ADDENDUM NUMBER 1

NOTIFICATION DATE:	BID TITLE:	BID NUMBER:	BID OPENING DATE & TIME:
03/25/16	AQUIFER STORAGE AND RECOVERY TEST WELL NUMBER 4	16-031	04/05/2016 2:00PM

CITY OF NAPLES - UTILITIES DEPARTMENT
ASR WELL #4
 WASTEWATER TREATMENT FACILITY

Exhibit B - ASR Test Well Drawing

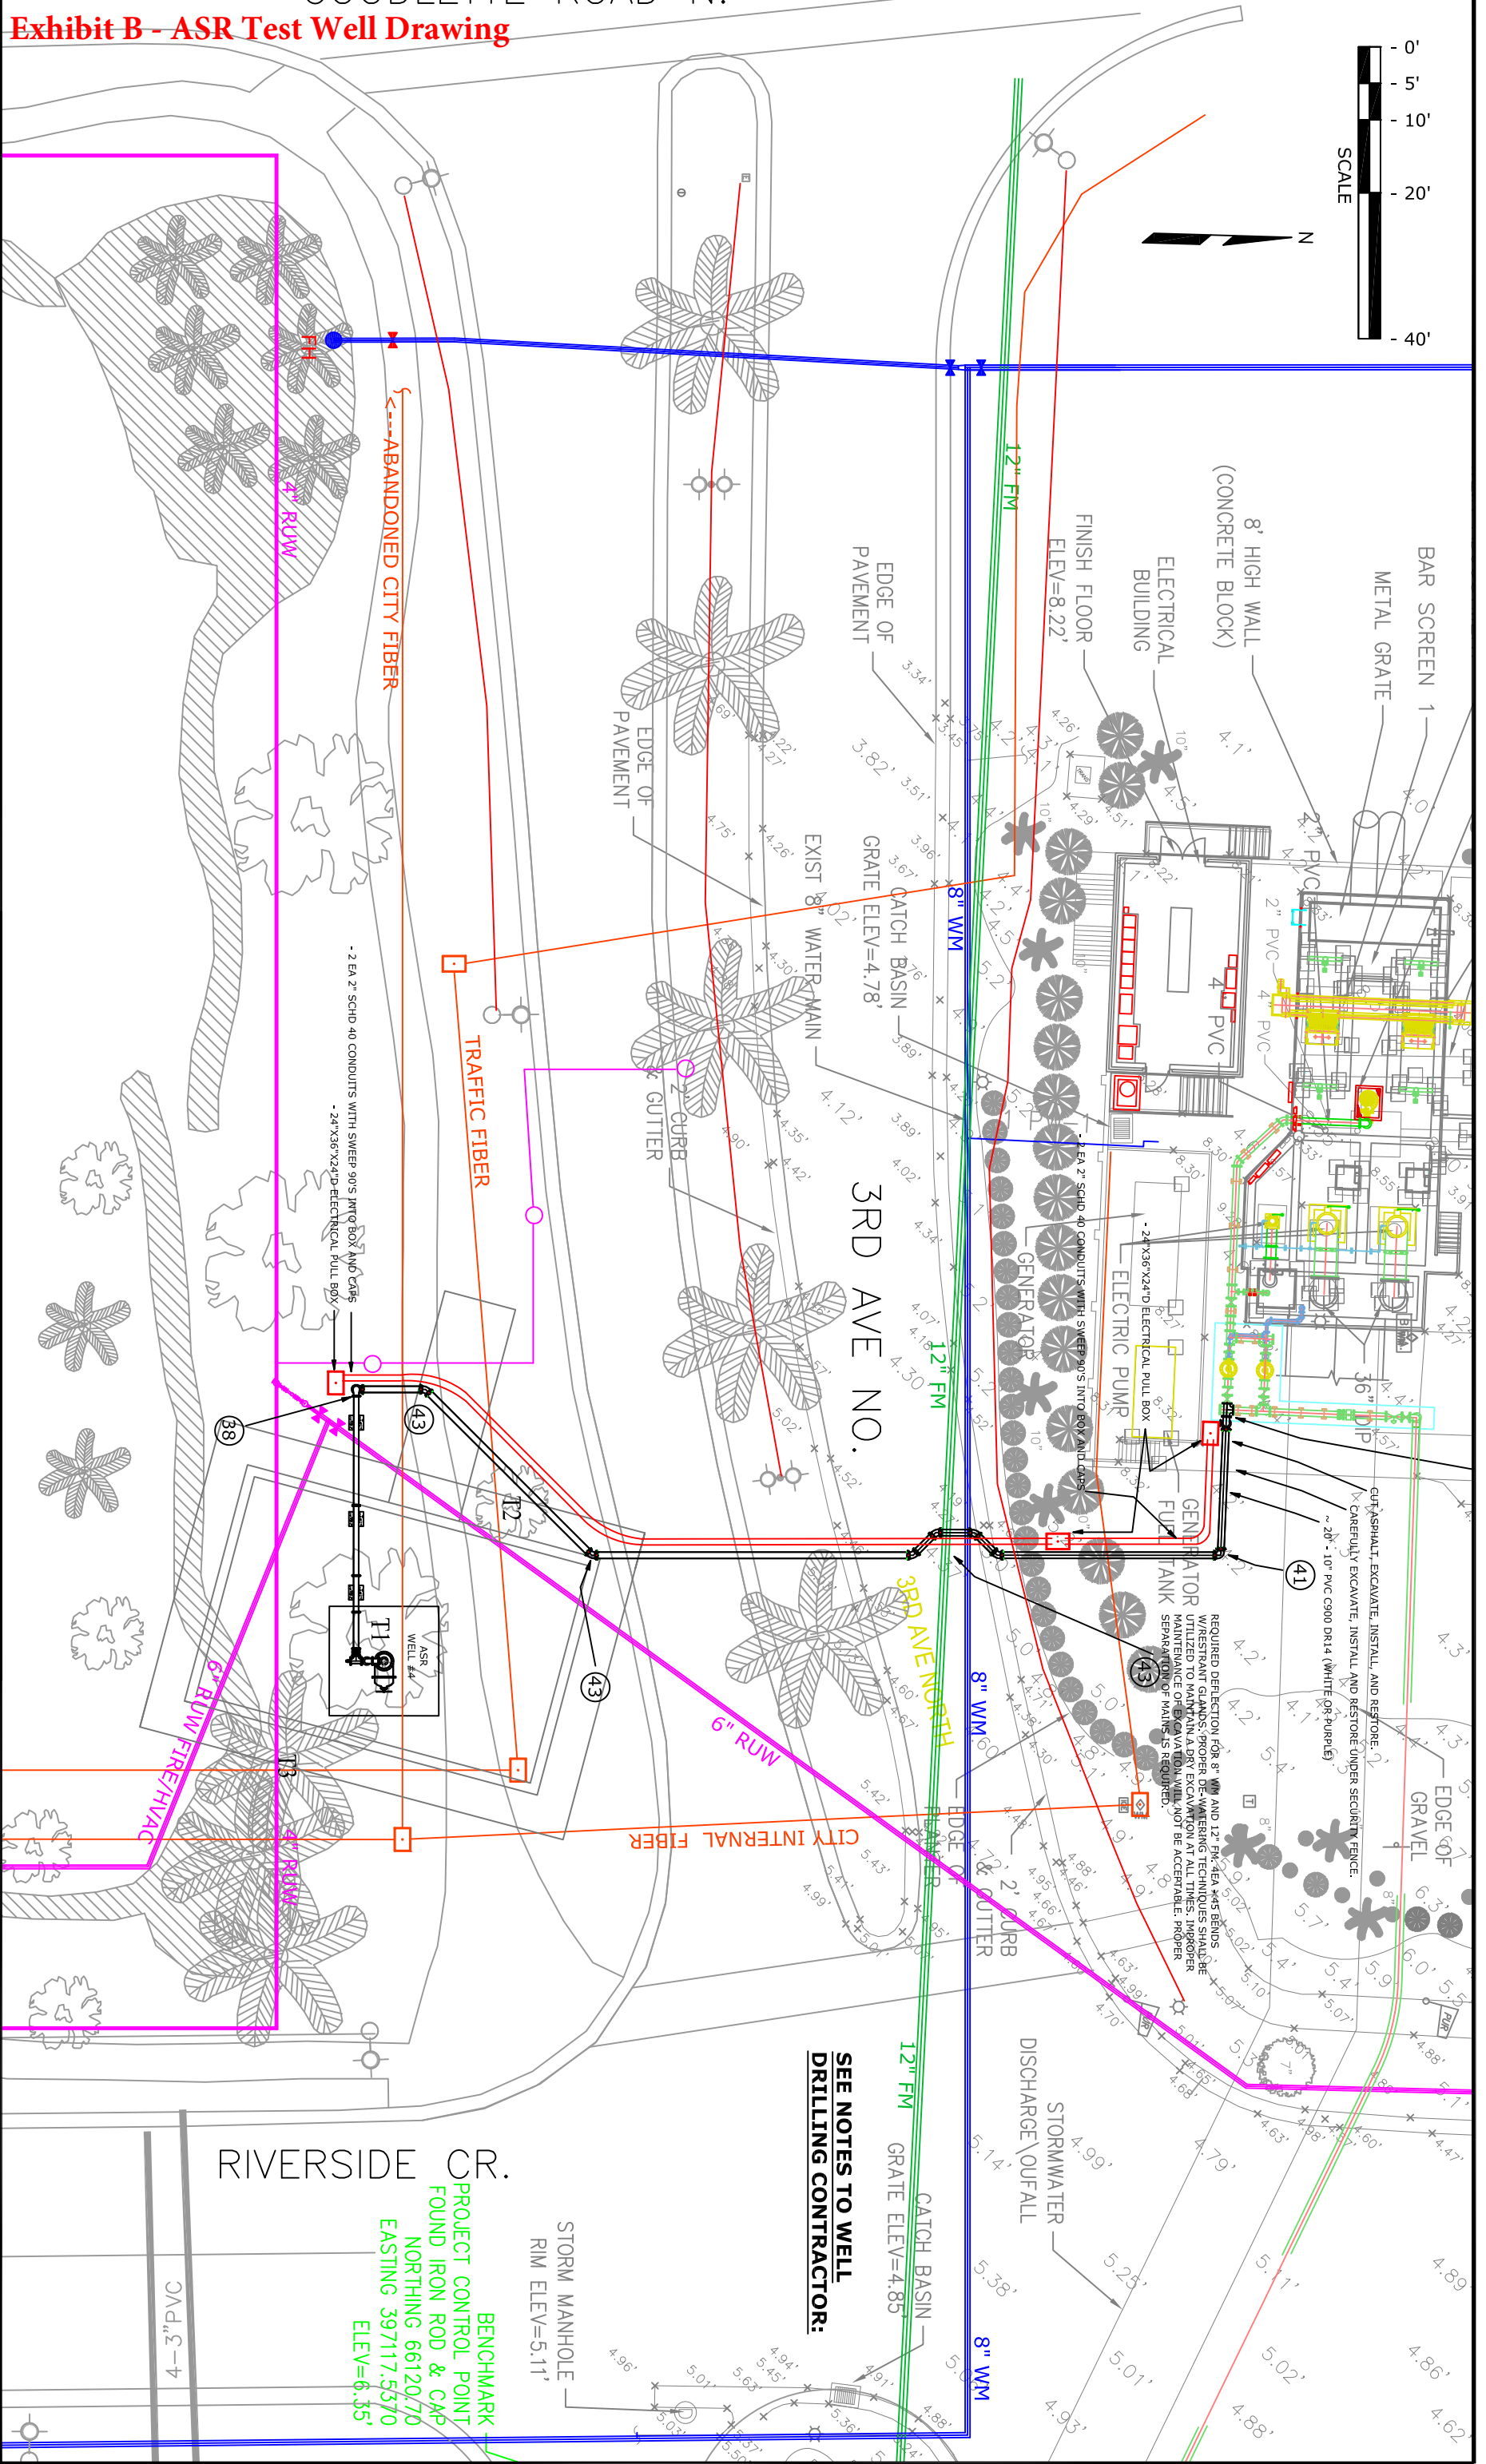
5. Exhibit B - “ASR Test Well Drawing” has been provided to define the approximate location of the well and the elevation of the well head flange.
6. Exhibit C – “Additional Notes to Well Drilling Contractor” has been provided.

SEE NOTES TO WELL DRILLING CONTRACTOR:

REQUIRED DEFLECTION FOR 8" WM AND 12" FM 4EA 45° BENDS
 W/RESTRAINT GUARDS. PROPER DE-WATERING TECHNIQUES SHOULD BE
 UTILIZED TO MAINTAIN A DRY EXCAVATION AT ALL TIMES. IMPROPER
 MAINTENANCE OF EXCAVATION WILL NOT BE ACCEPTABLE. PROPER
 SEPARATION OF MAINS IS REQUIRED.

CUT ASPHALT, EXCAVATE, INSTALL AND RESTORE.
 CAREFULLY EXCAVATE, INSTALL AND RESTORE UNDER SECURITY FENCE.
 ~ 20' - 10" PVC C900 DR14 (WHITE OR PURPLE)

- Contractor shall be responsible to remove and dispose of trees T1 & T2 labeled on drawing; using due care to prevent damage to existing underground utilities. Contractor cannot remove palm tree T3 and may have to provide protection and support during well operations.

- Contractor shall install 24" well casing flange at +7.99 Elevation NAVD.
- Contractor shall install City supplied 24" Gate Valve w/hardware-gasket. The valve operator shall be positioned due east.

- City will provide all other piping for project by Underground Contractor. An 8" Flanged 90 shall be provided at site 38 labeled on drawing for well discharge. Well contractor shall provide necessary piping to fitting 38.
